**UNITED STATES ENVIRONMENTAL PROTECTION AGENCY
REGION 1
5 POST OFFICE SQUARE, SUITE 100
BOSTON, MA 02109-3912**

SUBJ: GE-Pittsfield/Housatonic River Site: EPA Response to GE
Statement of Position in Dispute Resolution Proceedings

**EPA's RESPONSE TO GE'S STATEMENT OF POSITION ON DISPUTED
CONDITIONS 20 AND 22 OF EPA'S JANUARY 15, 2010 CONDITIONAL
APPROVAL LETTER**

Figure G-1 – Method B for Determining Schedule for SED 9

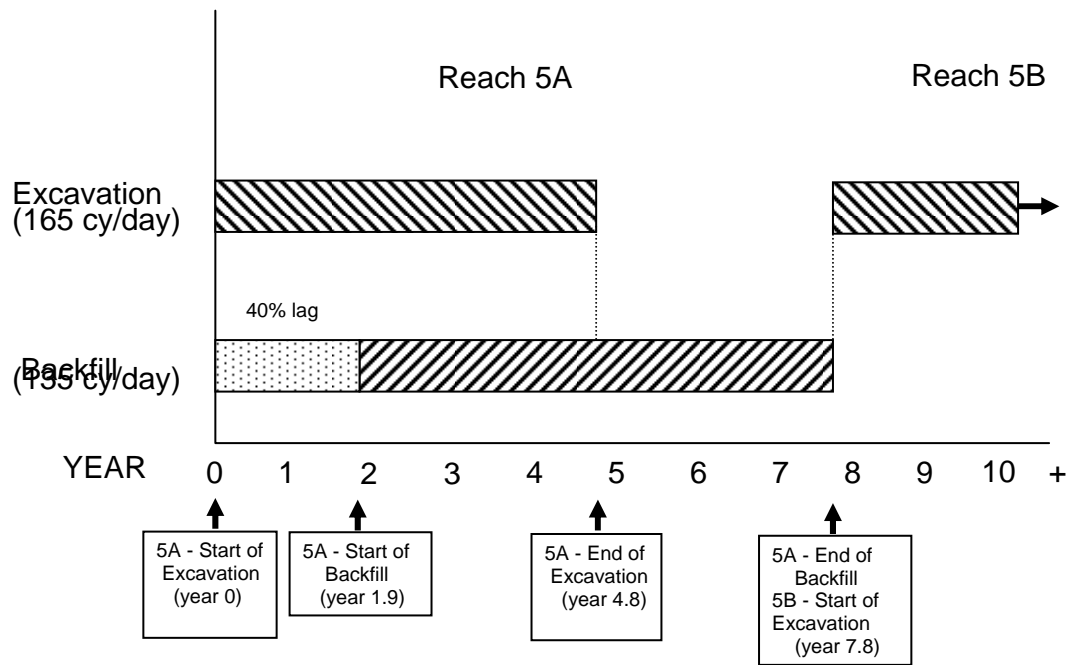
It thus appears that when calculating the overall durations for each Reach, GE factored in backfill in a manner that is inconsistent with GE's March 2009 response to Comment 49 (Attachment F, at 202). In addition, it appears that GE does not begin excavation in the downstream Reach until completion of backfill has occurred in the upstream Reach (Figure 1).

The volume of material to be excavated in Reach 5B includes 88,000 cy of sediment plus 9,000 cy of bank soil, for a total of 97,000 cy. The 33,000 cy of bank soil material agreed upon for Reaches 5A and 5B was pro-rated by the length of Reach 5A compared to the length of Reach 5B.

Bank soil excavation and backfill activities will be conducted concurrent to sediment excavation and backfill activities in Reaches 5A and 5B.

Frequency of River Velocity in Reaches 5B and 5C

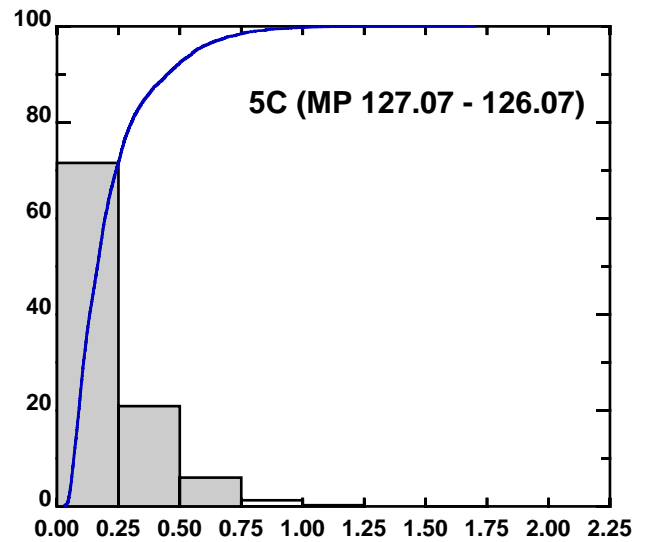
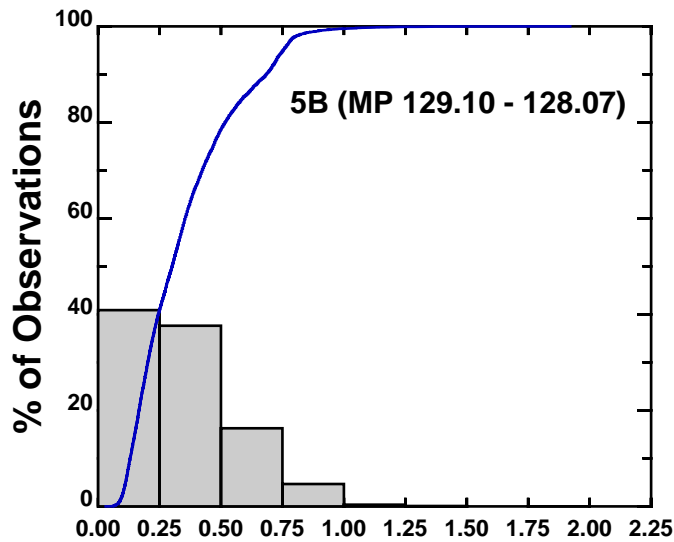
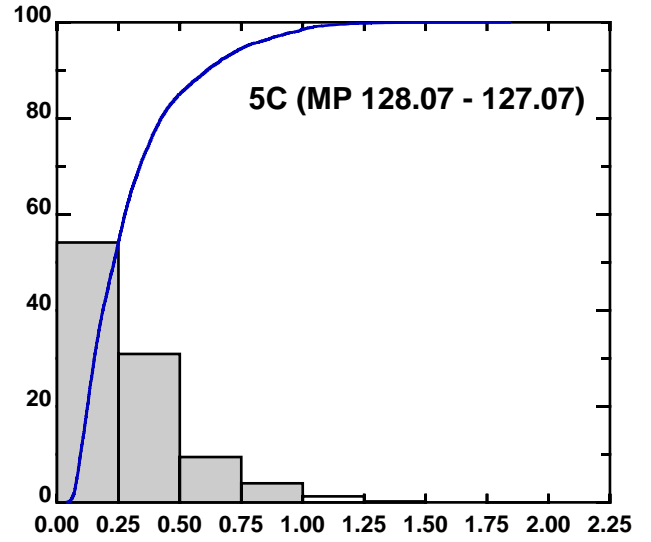
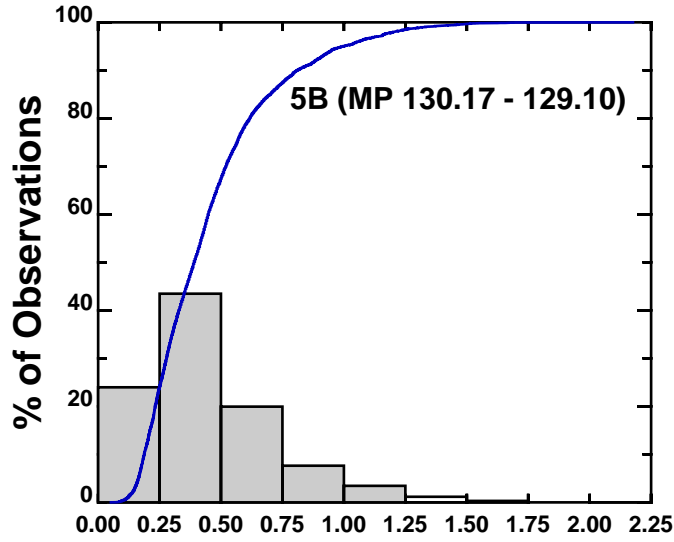
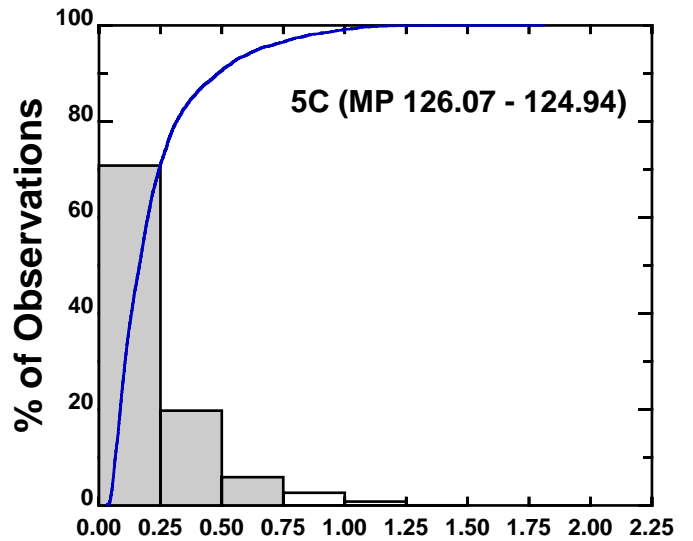
c. EPA's Rejection of a Lower Production Rate Due to River Flow Conditions in Reaches 5A and 5B Had No Supportable Rationale.

In addition, EPA did not provide a supportable rationale for disapproving GE's proposal to reduce the production rates in both Reaches 5A and 5B (compared to Reach 5C and downstream) to account for the likely increased downtime due to higher water current velocities. It gave no reason at all for rejecting the point that the higher velocities in those reaches will limit the ability to work in the river on some days, thus requiring a modification in the production rate (in addition to the general downtime modification for any mechanical dredging, which was based on many other factors besides flow).¹⁰

GE's conclusion that river conditions in Reaches 5A and 5B would limit the ability to work in the river and thus warrant a further reduction in the production rate is supported by review of the number of days when water depth would prevent safe operation of equipment within the river channel in Reach 5A. For purposes of this analysis, it is assumed that conventional equipment could not operate safely in water depths greater than 3 feet, so if a substantial portion of the river (e.g., more than 75%) had water depths over 3 feet, work within the river channel would not be able to be performed. GE has estimated that this would occur, on average, on approximately 36 days over the assumed annual 198-day construction season.¹¹ This estimate was based on use of the hydrodynamic model developed by EPA. The graph below shows the percentage of area in Reach 5A having model-predicted water depths greater than 3 feet during the assumed construction season, corresponding to various ranges of flow (at Pomeroy Avenue Bridge near the upstream end of Reach 5A).¹²
